# 82527

## Specification Update

*June, 1998*

Order Number: [272876-002](#)

**Figure 1. Bus Cycle for Mode 0 or Mode 1 Operation (Read Cycle)**

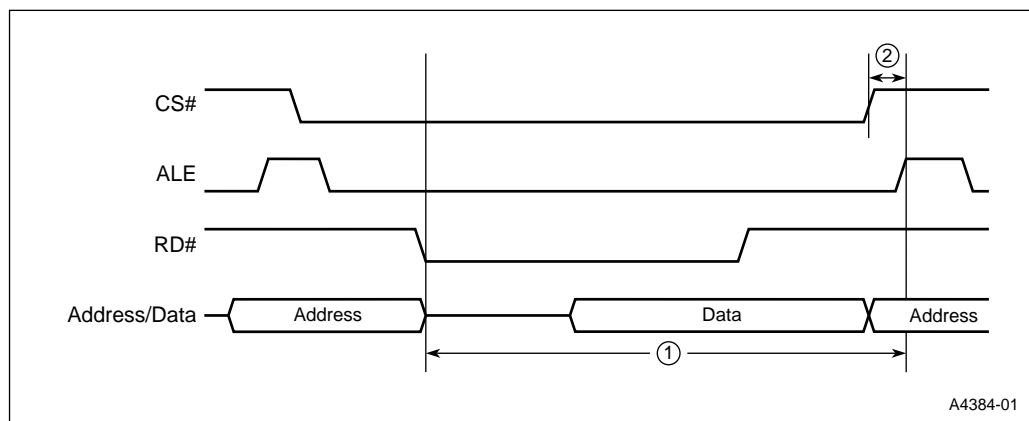
For mode 0 and mode 1 (Intel multiplexed modes), the control signals ALE, RD# and WR# are used to define the address and whether the cycle is a data read or write operation. The ALE signal is commonly used to latch the address information and generate a CS# signal to the 82527. The problem occurs in this configuration when the next cycle ALE is asserted before CS# of the current cycle becomes invalid. This circumstance presents a problem only when CS# is active and the next cycle’s ALE occurs less than  $1.5 t_{MCLK}$  after the current cycle’s RD# low. ( $t_{MCLK} = t_{OSC}/[(1 + DSC \text{ bit}) + DMC \text{ bit}]$  where DSC = Divide System Clock, DMC = Divide Memory Clock.

When performing “fast reads” associated with the double-read operation in mode 0 or 1, one of the following two conditions must be true:

1. The time from RD# low of the current cycle to the next ALE must be greater than  $1.5 t_{MCLK}$ , or
2. The CS# signal to the 82527 must be inactive before the next occurrence of an ALE, when the time from the RD# low of the current cycle to the next cycle’s CS# active is less than  $1.5 t_{MCLK}$ .

**Figure 2. Bus Cycle for Mode 2 Operation (Read Cycle)**

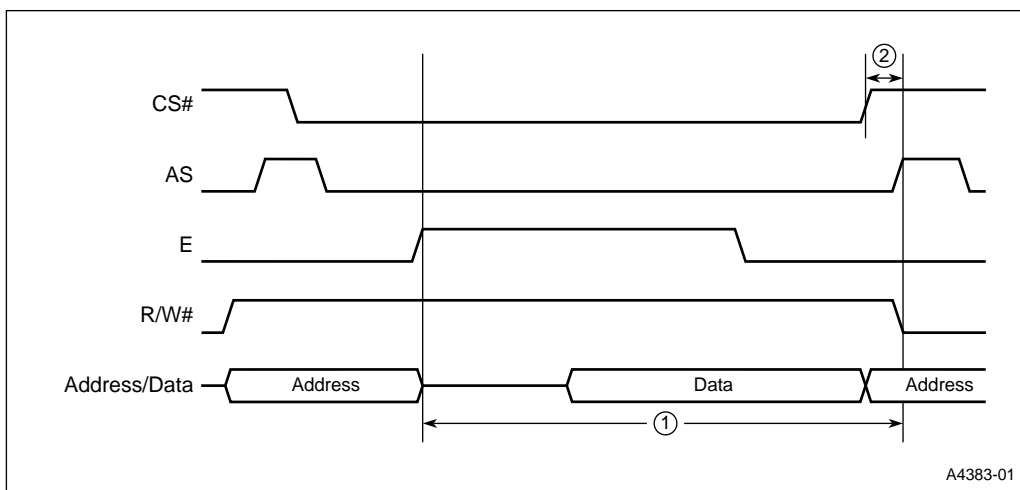
For Mode 2, the control signals AS, R/W#, and E are used to define the address, to specify whether the cycle is a data read or write operation, and to synchronize the memory accesses. The AS signal is commonly used to latch the address information and generate a CS# signal to the 82527. The problem, as outlined for Modes 0 and 1, occurs when the next cycle's AS is asserted before CS# of the current cycle becomes invalid. This circumstance presents a problem only if the next cycle's AS occurs in less than  $1.5 t_{MCLK}$  after the current cycle's E low while CS# is still active.

For Mode 2 operation, one of the following two criteria must be true:

1. The time from E high of the current cycle to the next AS must be equal to or greater than  $1.5 t_{MCLK}$ , or
2. The CS# signal to the 82527 must be inactive before the next occurrence of an AS, when the time from E high of the current cycle to the next cycle CS# active is less than  $1.5 t_{MCLK}$ .

**Figure 3. Bus Cycle for Mode 3 Synchronous Operation (Read Cycle)**

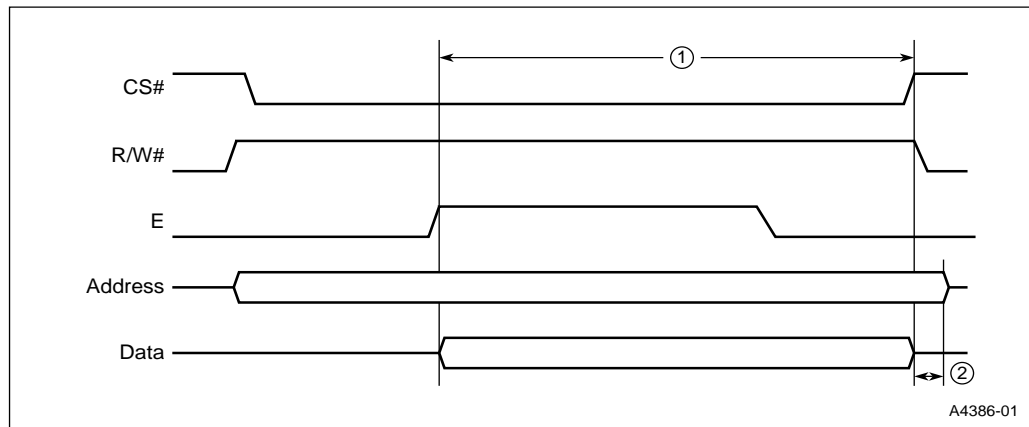
For mode 3 synchronous operation, there is no ALE or AS signal. Mode 3 is the demultiplexed mode of the 82527. For this mode, the address information must be present through the entire cycle. However, when performing fast read operations, similar considerations as the other modes must be observed to prevent problems when performing reads from the 82527.

For mode 3 synchronous operation, one of the following two criteria must be true:

1. The time from E high of the current cycle to CS# invalid must be equal to or greater than  $1.5 t_{MCLK}$ , or
2. Address information must remain valid on the bus until after CS# goes inactive.

**Figure 4. Bus Cycle for Mode 3 Asynchronous Operation (Read Cycle)**

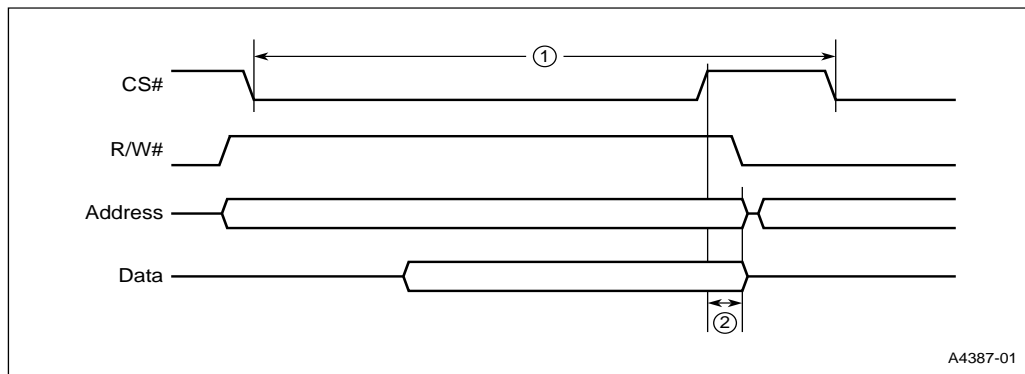
Mode 3 asynchronous is also a demultiplexed mode of operation on the 82527. This mode is typically used with the DSACK0# signal. When using mode 3 asynchronous with host CPUs that do not have the DSACK0# input, the following considerations must be observed to prevent problems when performing reads of the 82527.

For Mode 3 asynchronous (no DSACK0#), both of the following criteria must be true:

1. The time between consecutive CS# cycles must be equal to or greater than  $2 t_{MCLK}$ .
2. Address information must remain present on the bus until after CS# goes inactive.
